RIVERSIDE HEALTH SYSTEM 2ND ADDITION

WICHITA, SEDGWICK COUNTY, KANSAS

Re: S/D97-83 -- One Step Final Plat of RIVERSIDE HEALTH SYSTEMS 2ND ADDITION

Re: S/D97-83 -- One Step Final Plat of RIVERSIDE HEALTH SYSTEMS 2ND ADDITION

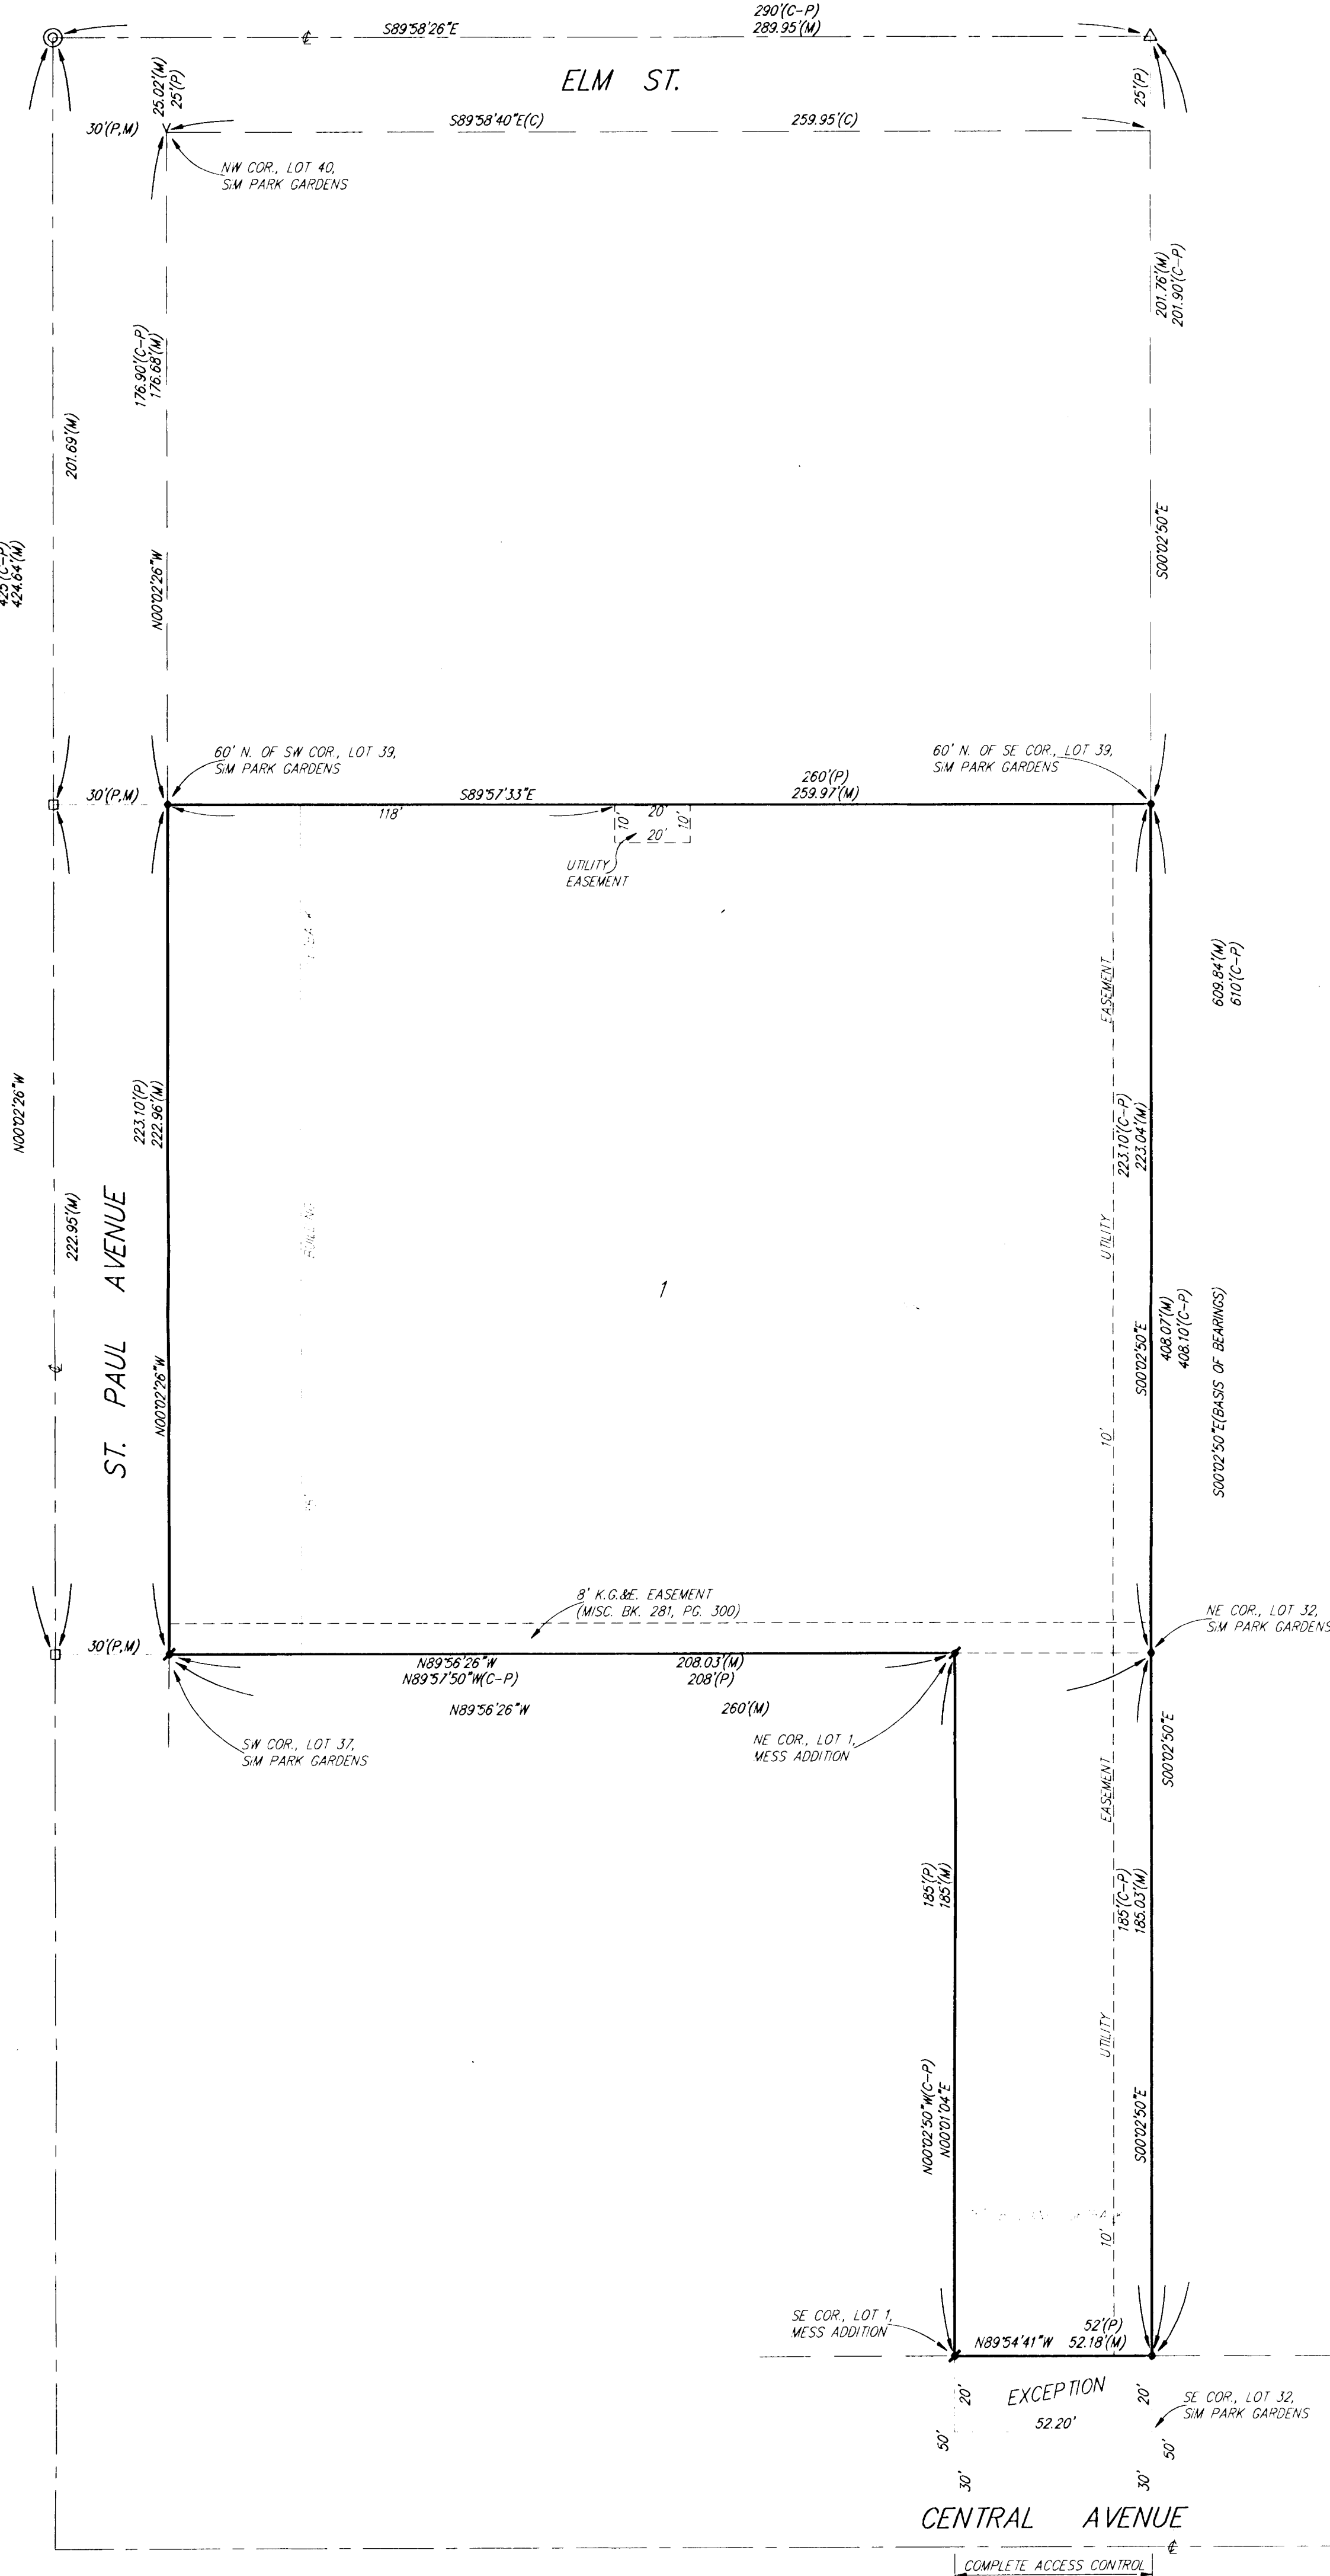
- A. City Engineering needs to indicate if any additional guarantees are required for water or sanitary sewer improvements to serve this site.
- B. If improvements are guaranteed by petition, a notarized certificate listing the petitions shall be submitted to the Planning department for recording.

- C. A temporary easement will need to be established by separate instrument for the existing sanitary sewer line that is intended to be abandoned, unless the sewer line is abandoned before the plat is recorded. City Engineering requires a guarantee for the abandonment of the sewer line.

- D. Traffic Engineering needs to indicate the need, if any, for access controls. Traffic Engineering recommends complete access control along Central.

- E. City Engineering needs to comment on the status of the applicant's drainage plan. The drainage plan is approved. Improvements will be required at time of site development.

- F. The Subdivision Regulations require a 35-foot building setback from perimeter streets for commercial lots, which should be denoted on the final plat.

- G. As an office lot adjacent to a non-arterial street, the plat should designate a sidewalk along St. Paul Avenue, in accordance with the sidewalk ordinance.

- H. For portions of the site with existing tree rows that may be impacted by the installation of utilities, it is recommended that overly wide utility easements (30 foot) be platted in order to allow for the installation of the utilities without damage to such tree rows.

- I. The distance from the property to the centerline of Central Avenue should be denoted on the plat.
- J. The applicant shall install or guarantee the installation of all utilities and facilities which are applicable and described in Article 8 of the MAPC Subdivision Regulations. (Water service and fire hydrants required by Article 8 for fire protection shall be as per the direction and approval of the Chief of the Fire Department.)

- P. The representatives from the utility companies should be prepared to comment on the need for any additional utility easements to be platted on this property. **The Southwestern Bell representative requests additional easements as denoted on the attached plat.**
